ADDENDUM NO. 2

November 9, 2022

PROJECT: Dean Lee Research and Extension Center
PROJECT NO: 21011
ISSUED BY: Alliance Design Group, LLC

Dean Lee Research Center Tornado Damage

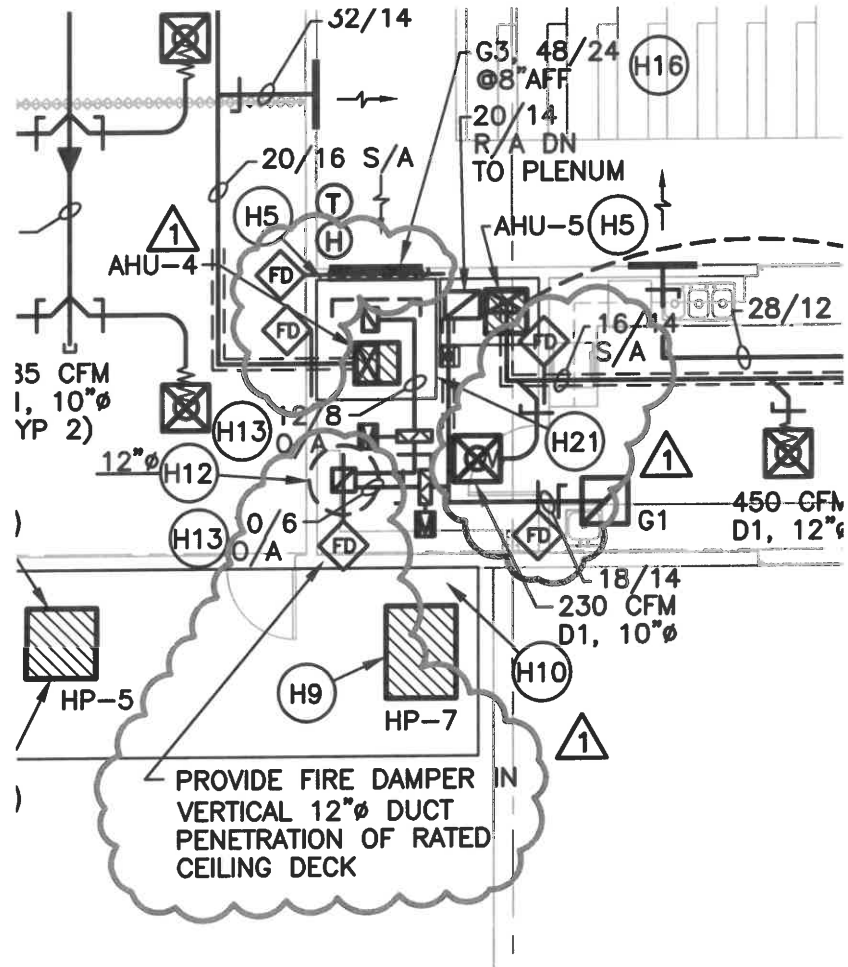
1. Lighting fixture C1 shall be 5000 lumens.
2. Lighting fixture F2, F2B shall be 40000 lumens. (50% up and 50% down)
3. Lighting fixture F3B shall be 5000 lumens.
4. Lighting fixture F7 shall be 2000 lumens.
5. Lighting fixture F8 shall be 3000 lumens.
6. Replace electrical legend with attached sketch AD2E1.

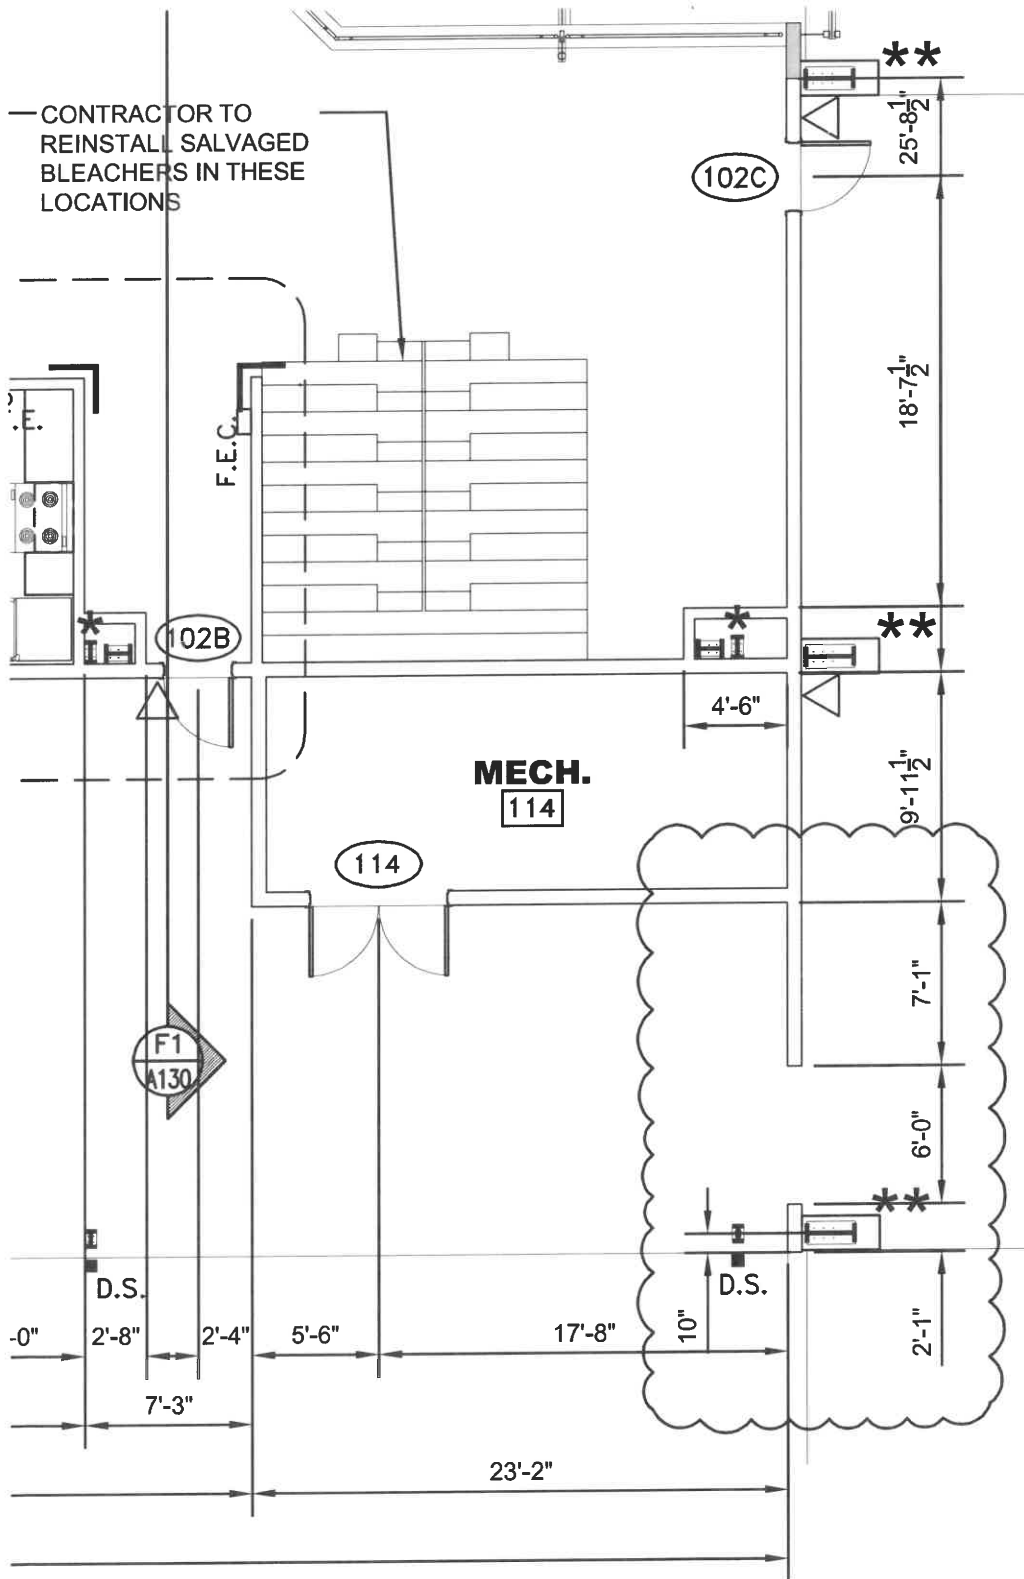
1. Provide fire dampers at duct penetrations of storage room per attached sketch AD2M1.

SHEET A703

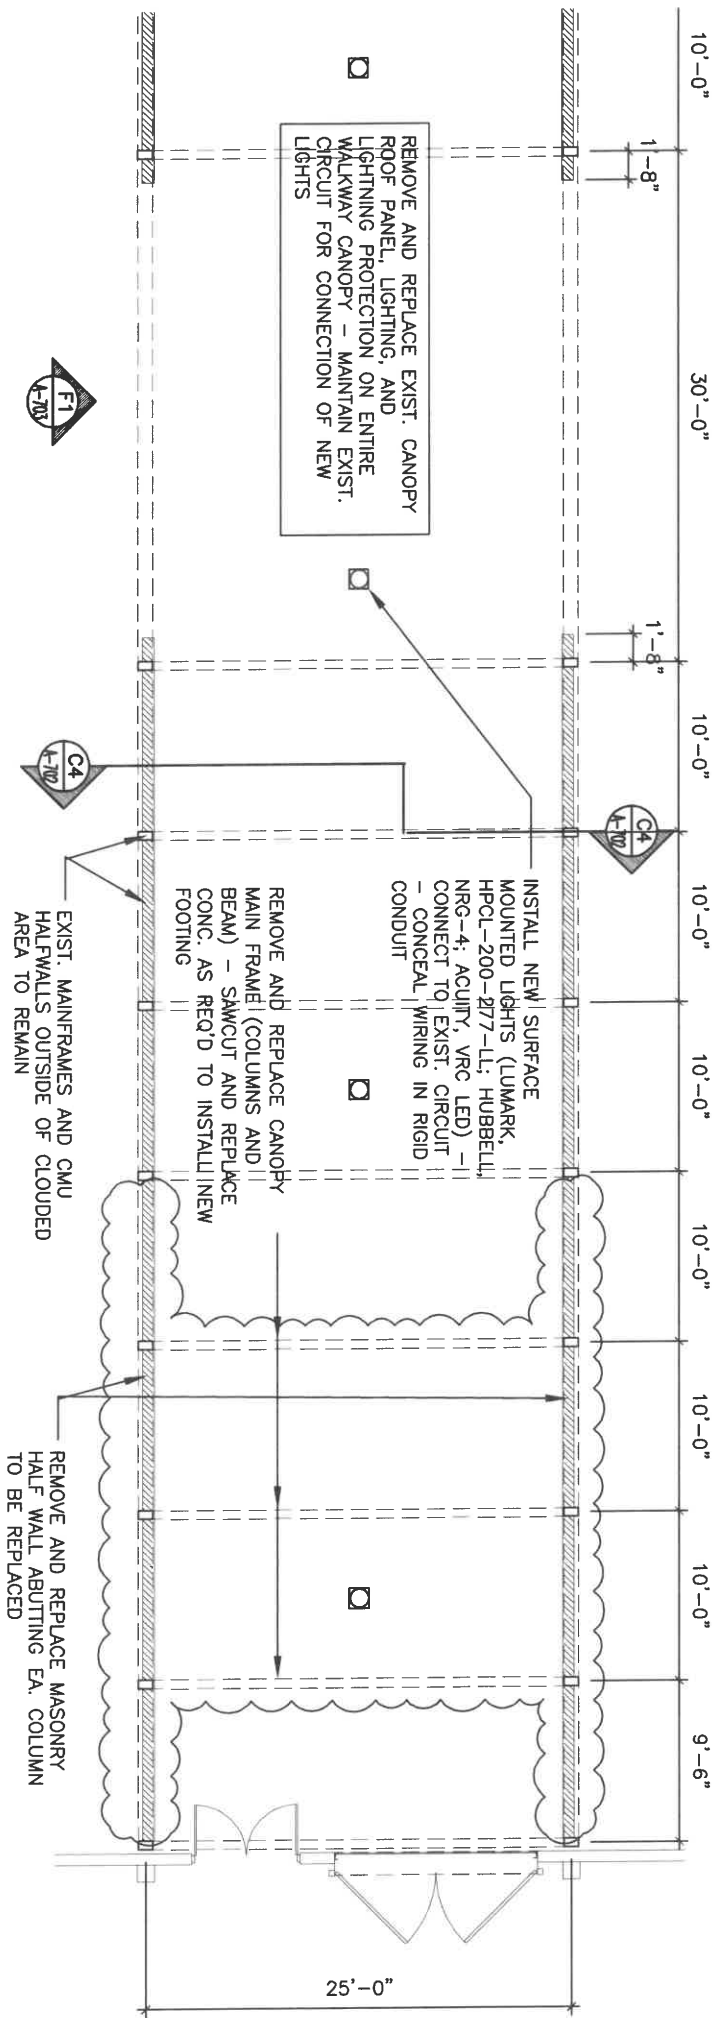
1. Revise Walkway Canopy Plan D1 and Elevation F1 as follows:
 - a. Remove and replace only 3 main frames (columns and beams). All other main frames shall remain. See attached sheet for location
 - b. Remove and replace CMU halfwall only at columns to be replaced. All other CMU halfwall shall remain.
 - c. Remove and replace roof panel on entire walkway canopy including all lighting, conduit, wiring, and lightning protection.

REMOVE AND REPLACE EXIST. CANOPY ROOF PANEL, LIGHTING, AND LIGHTNING PROTECTION ON ENTIRE WALKWAY CANOPY - MAINTAIN EXIST. CIRCUIT FOR CONNECTION OF NEW LIGHTS

INSTALL NEW SURFACE MOUNTED LIGHTS (LUMARK, HPCL-200-277-LI; HUBBELL, NRG-4; ACUITY, VRC LED) - CONNECT TO EXIST. CIRCUIT - CONCEAL WIRING IN RIGID CONDUIT

REMOVE AND REPLACE CANOPY MAIN FRAME (COLUMNS AND BEAM) - SAWCUT AND REPLACE CONC. AS REQ'D TO INSTALL NEW FOOTING

EXIST. MAINFRAMES AND CMU HALF WALLS OUTSIDE OF CLOUDED AREA TO REMAIN

REMOVE AND REPLACE MASONRY HALF WALL ABUTTING EA. COLUMN TO BE REPLACED
